Addendum No. 02

Issued: 9/13/2024

Project Name: Jordan Learning Center
Project No.: 2024528.00
Bid Package: 1

SHEET NUMBER:
SF504

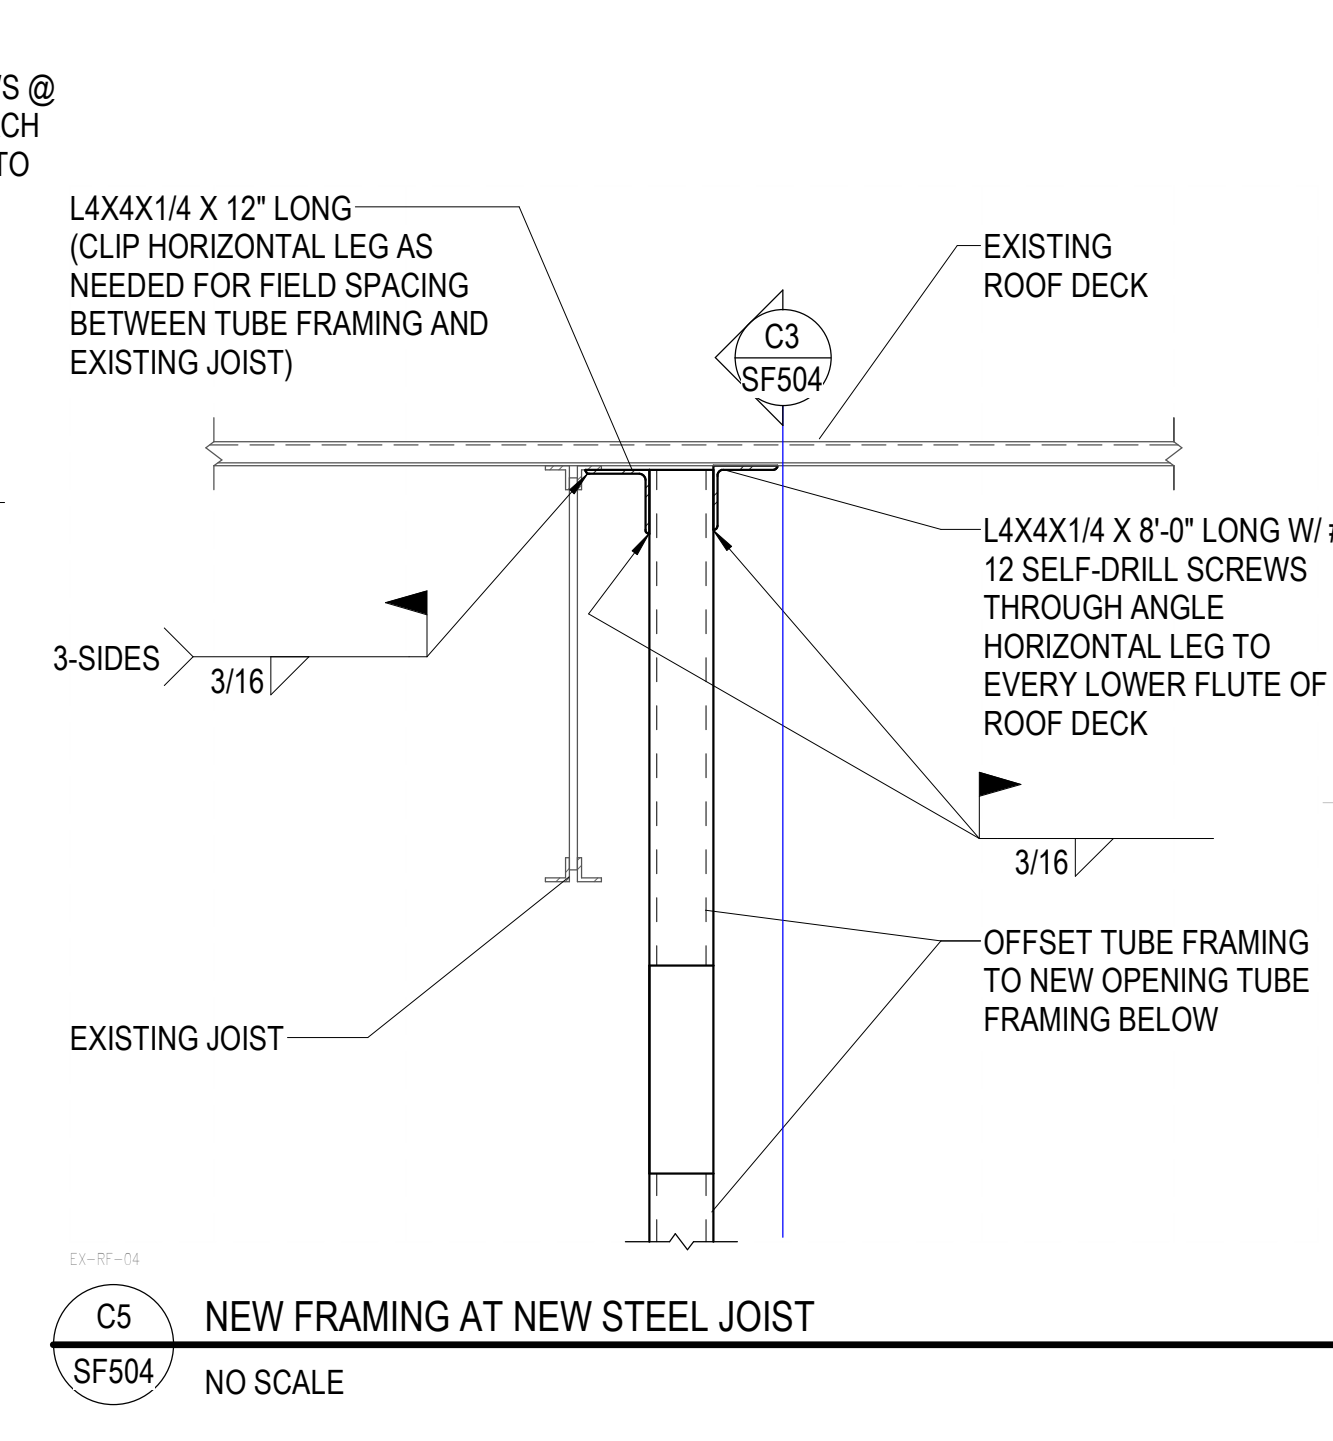
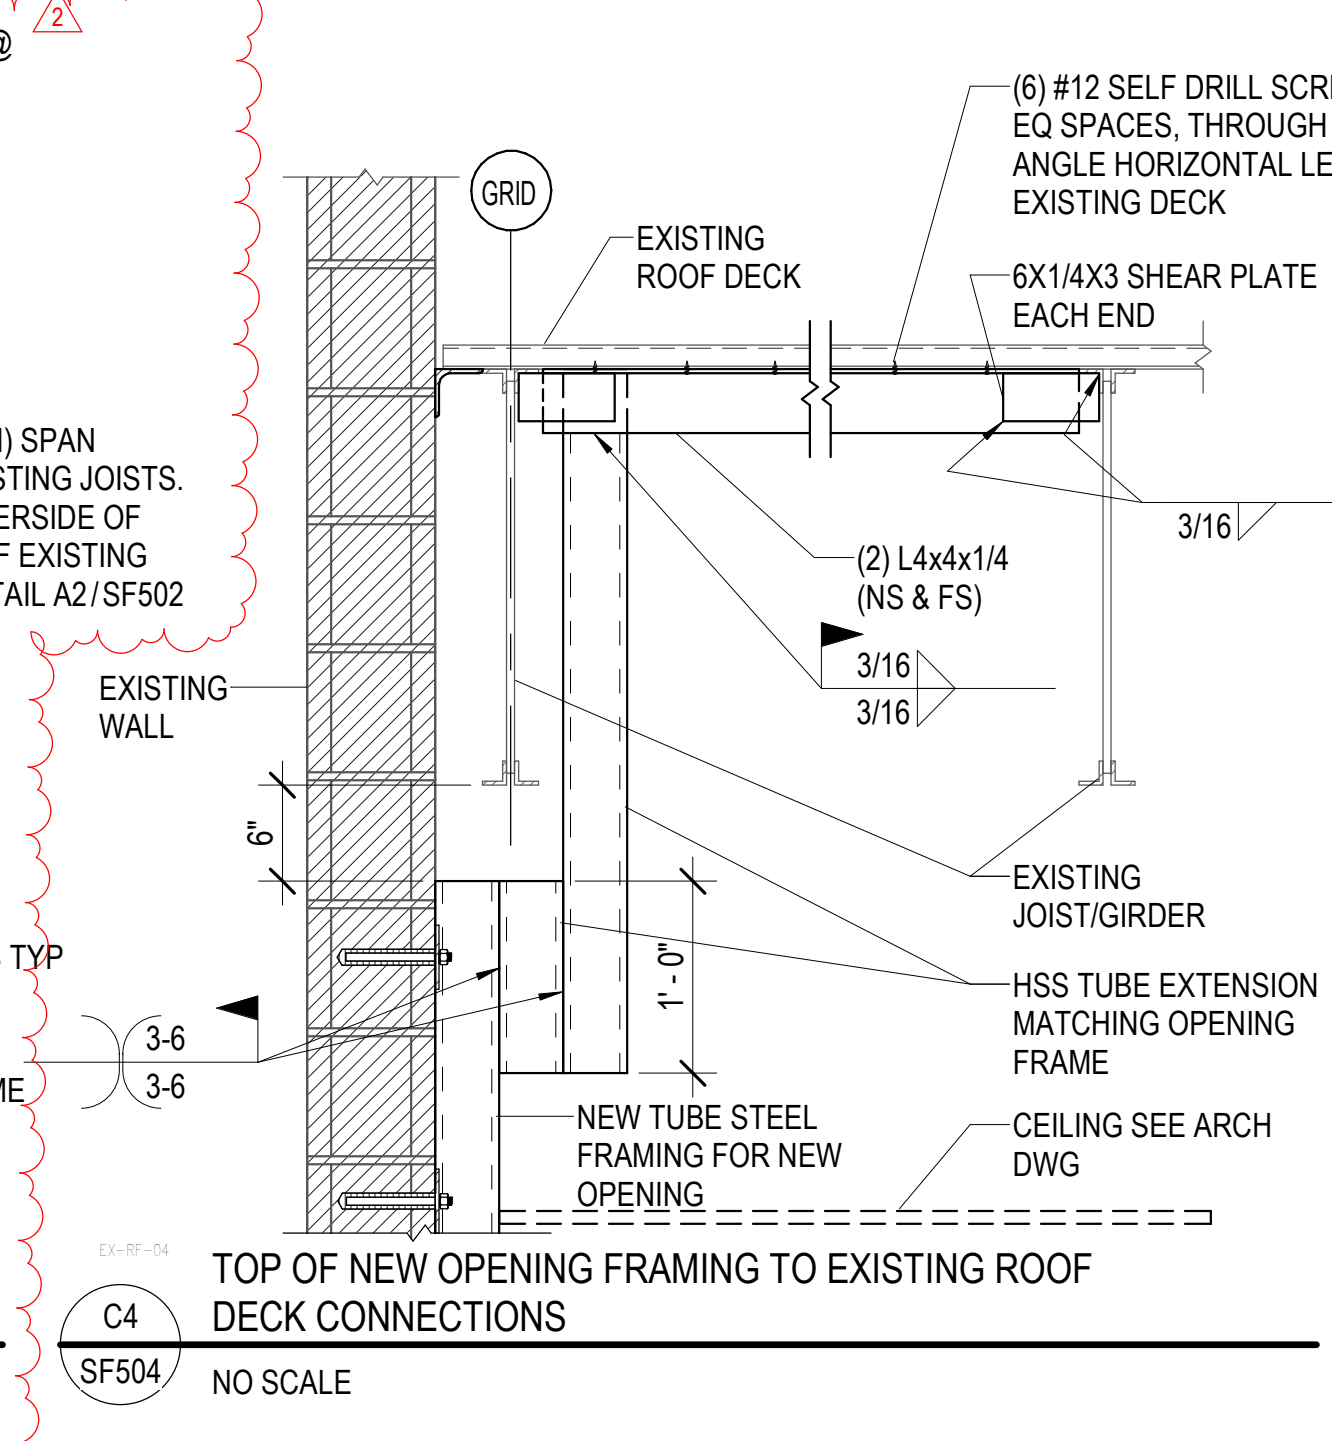
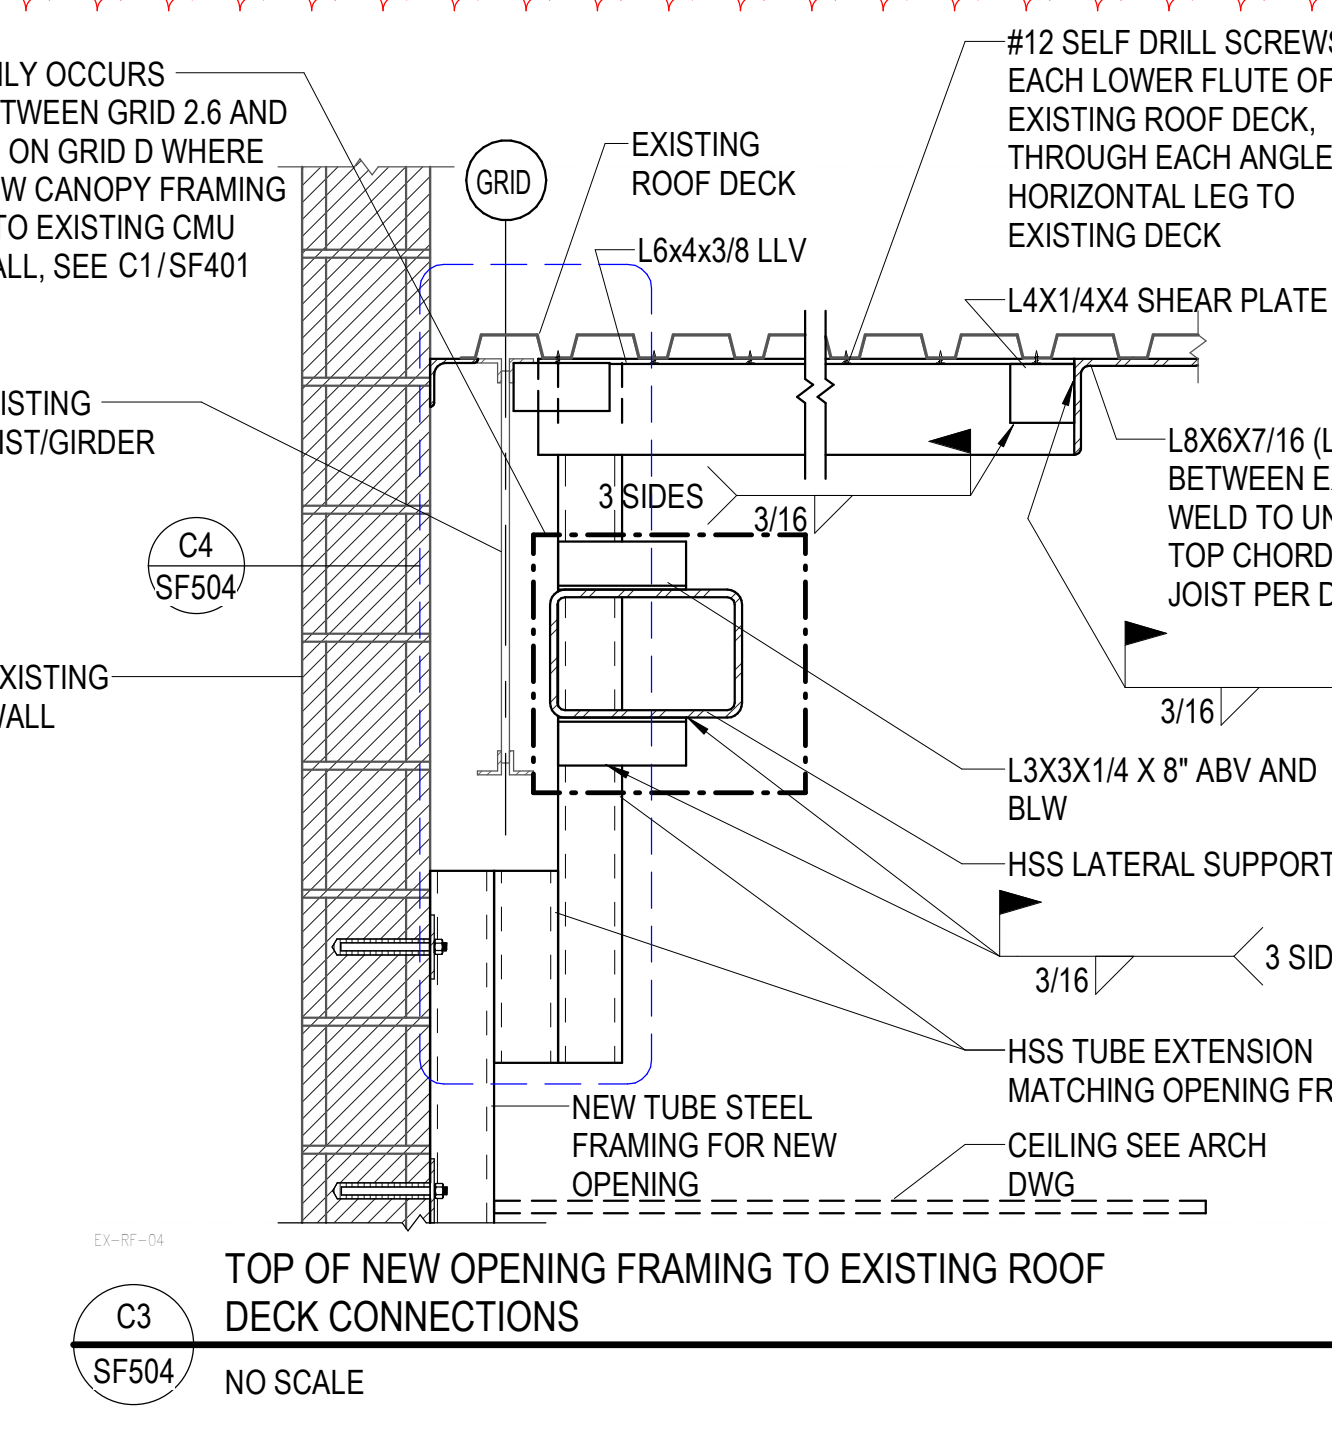
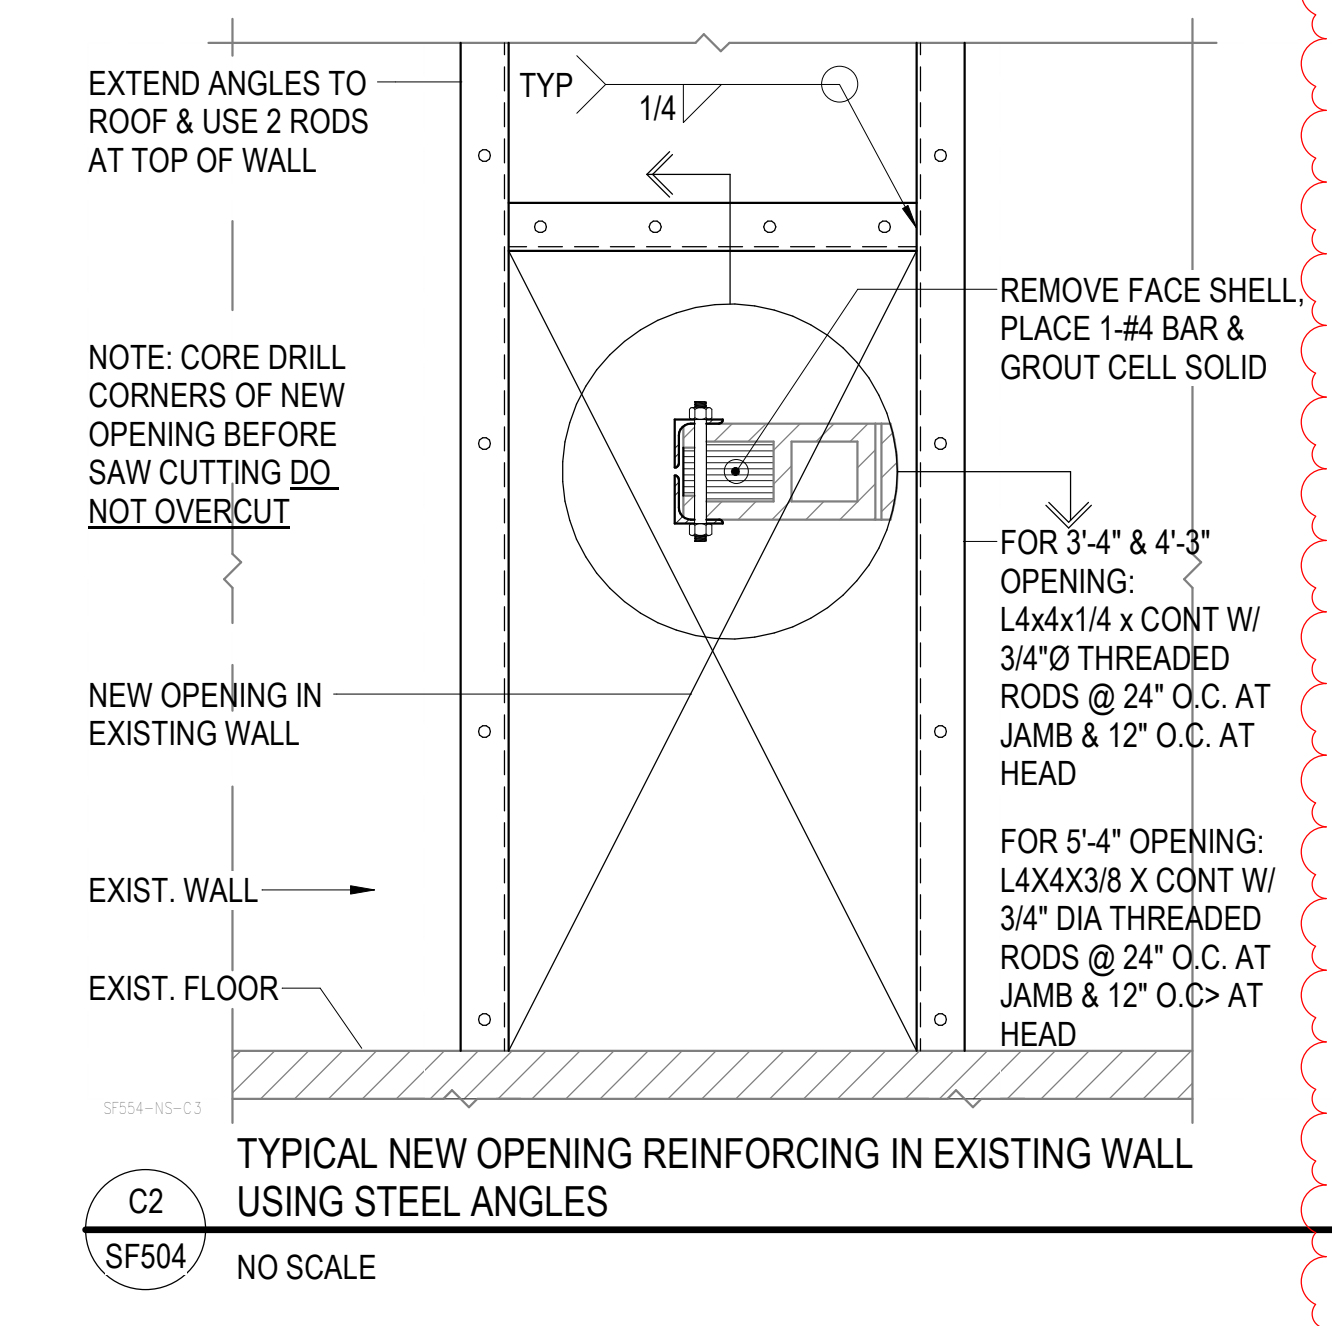
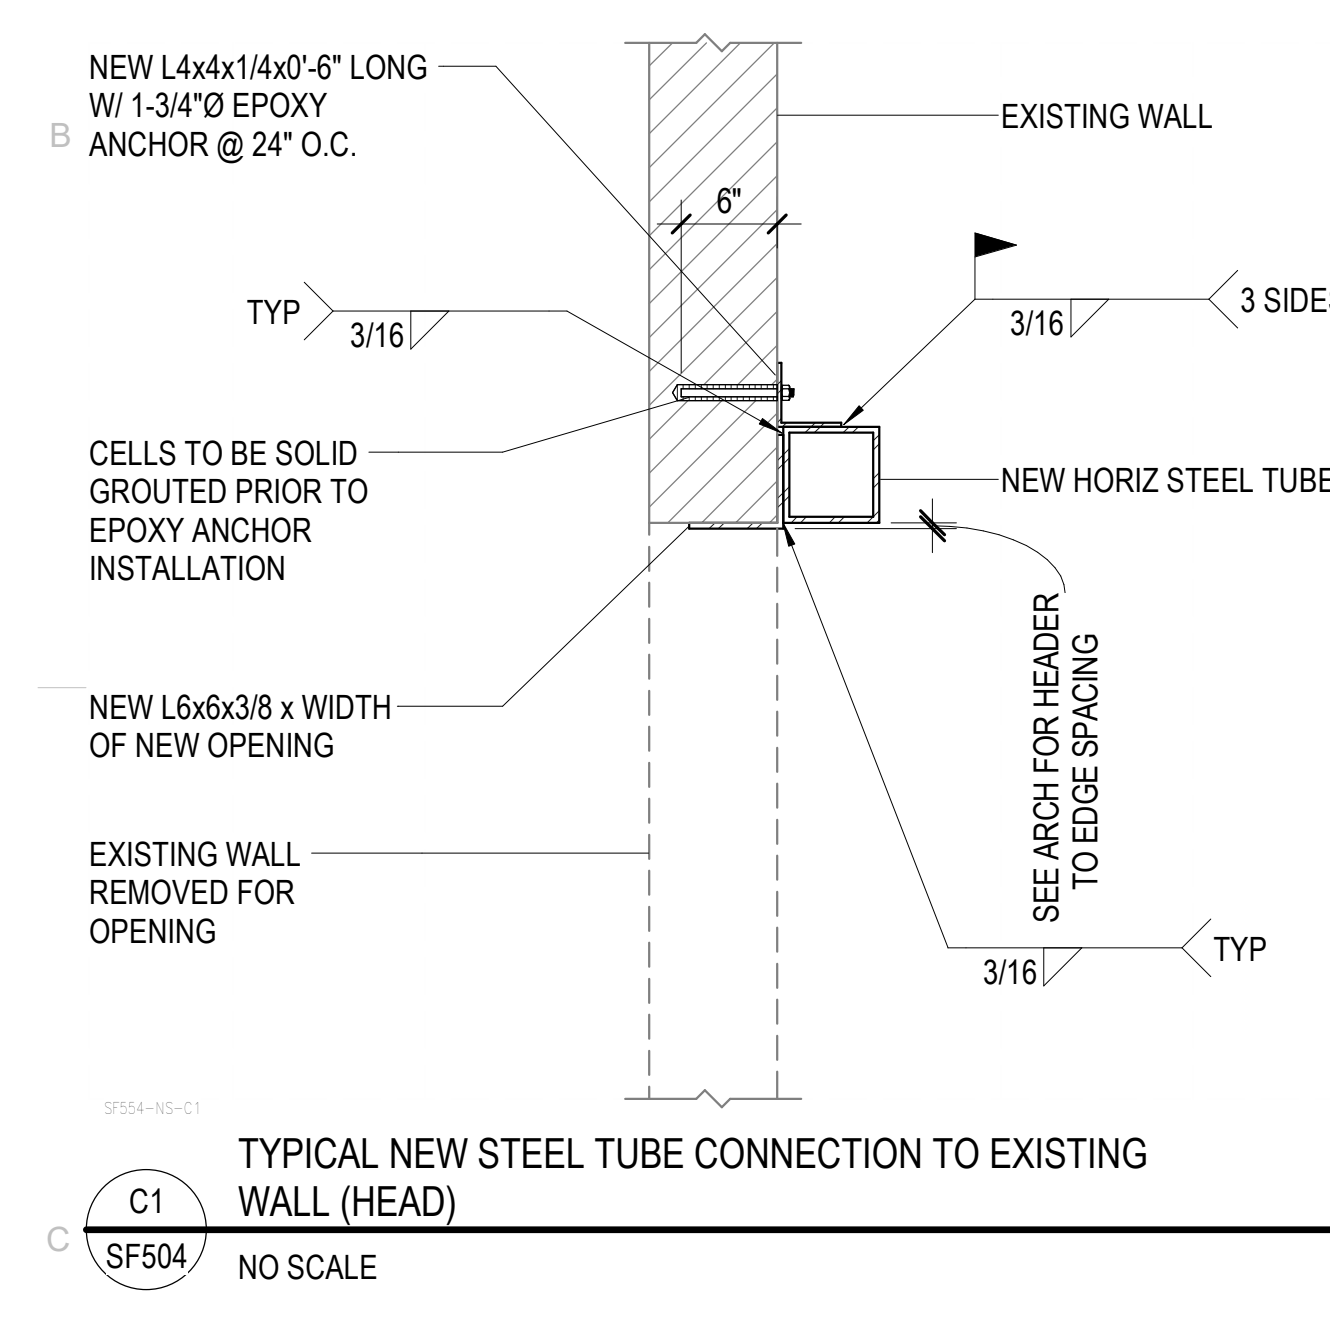
- Updated detail C3 to include HSS lateral support end connections.
- Revised references on details D1 and D2.
